2. Project Request

Central Kitsap School District is requesting approval of a Minor Revision to the preliminary approved Conditional Use Permit for the redevelopment of the Central Kitsap/Middle School Campus, consistent with KCC 17.550.040.

Based upon the analysis above and the decision criteria found in KCC 17.540.040.A and 050.A, the Department of Community Development recommends that the (Permit Type-I) request for CKHS Building 900 Minor Revision be **approved**, subject to the following 47 conditions:

L1.01

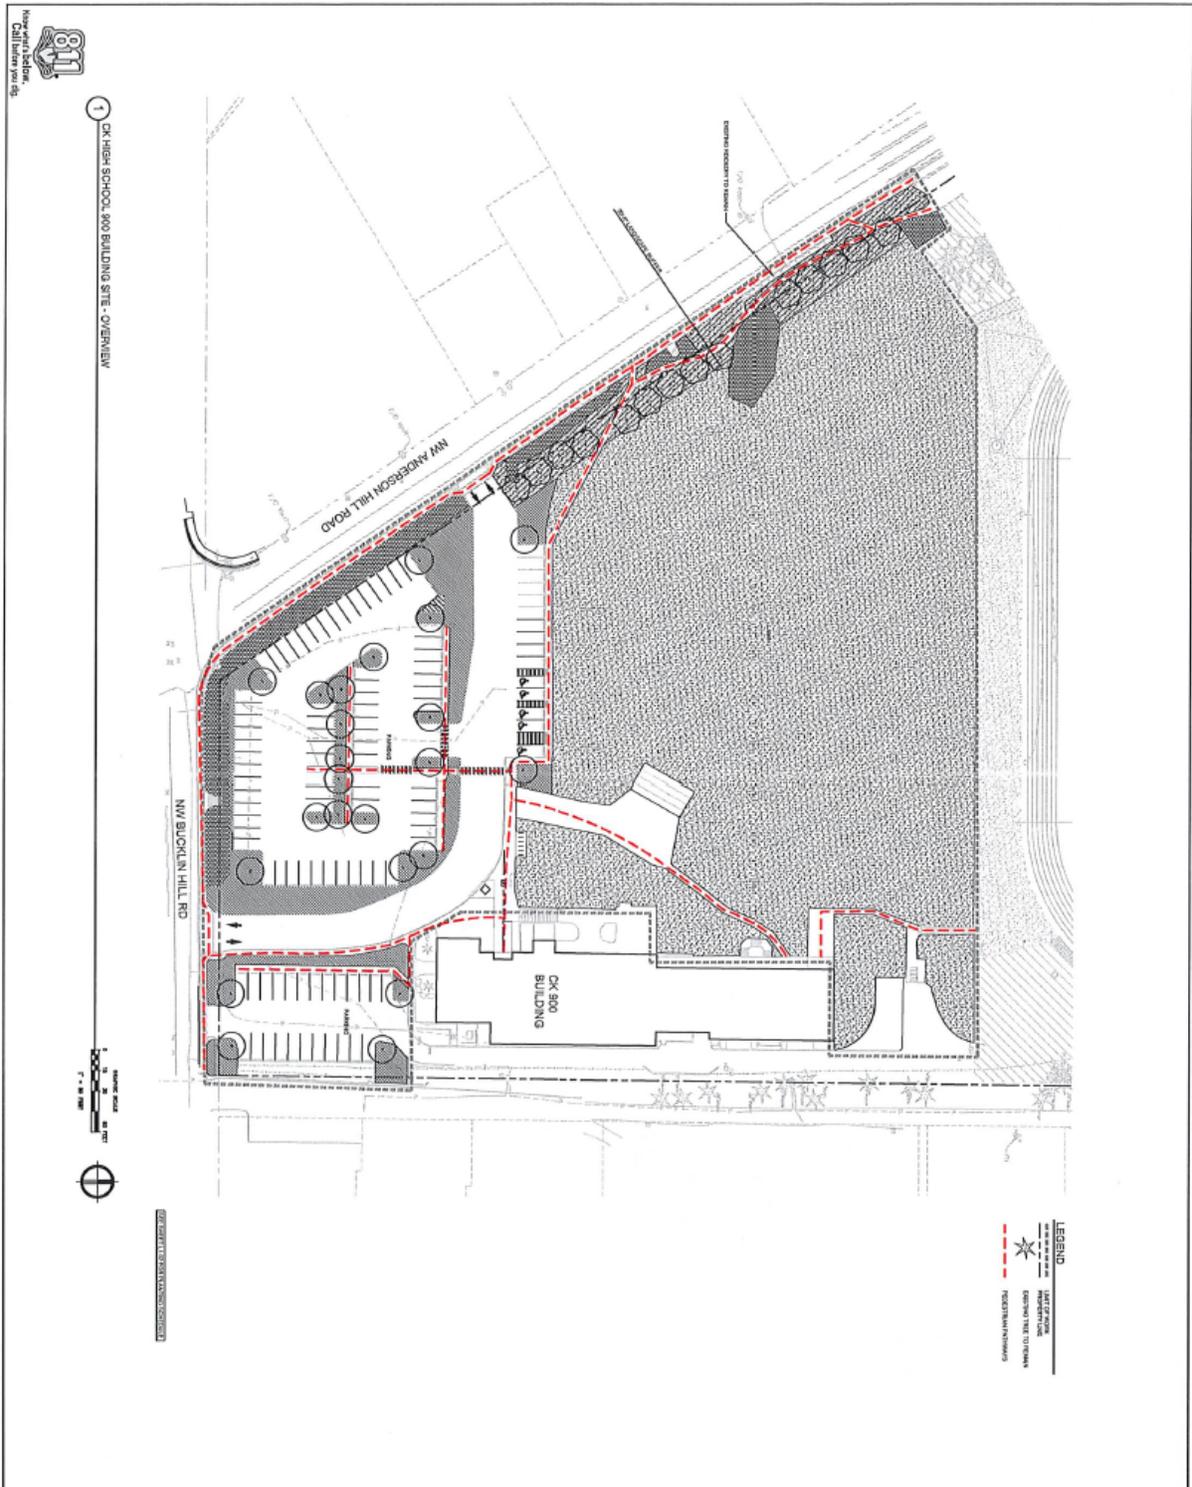
5. The applicant shall update the Planting Plan, dated 1/17/20 to show perimeter street trees consistent with requirements for Roadside/Setback Buffers (SDAP Permit # 19-04914).
